This is the Control Power Board for ADC, BLS and Muon LVPS. Top and Bottom traces.

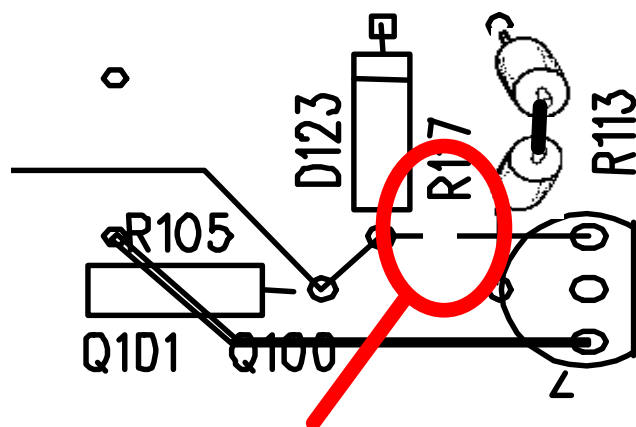
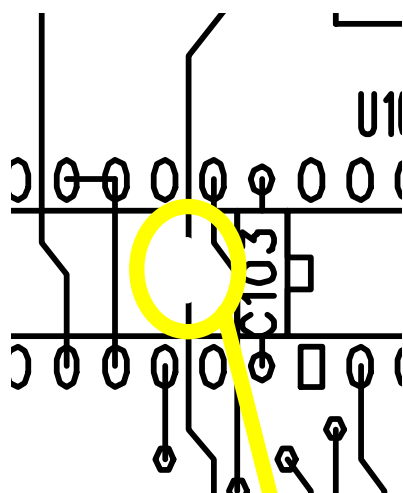
Cut trace between D123 and R117.
Remove R117 and replace with TWO resistors 200 Ω each.

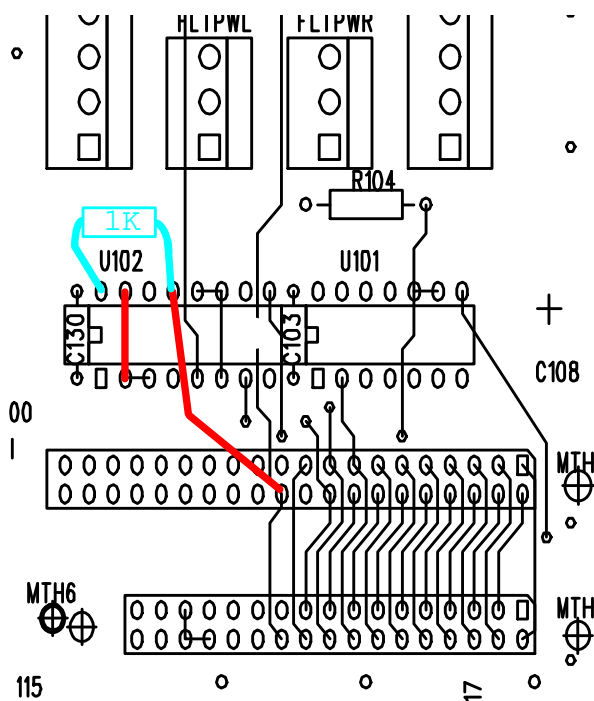
Cut trace on bottom of PC board and add jumper from U102-2 to U102-15. Add jumper from J100-22 to U102-13.

Wire from the two resistors to pin 14 of U102. Wire from pin 13 of U102 to R105-D123 junction. Cut trace on top of PC board between R117 and D123.
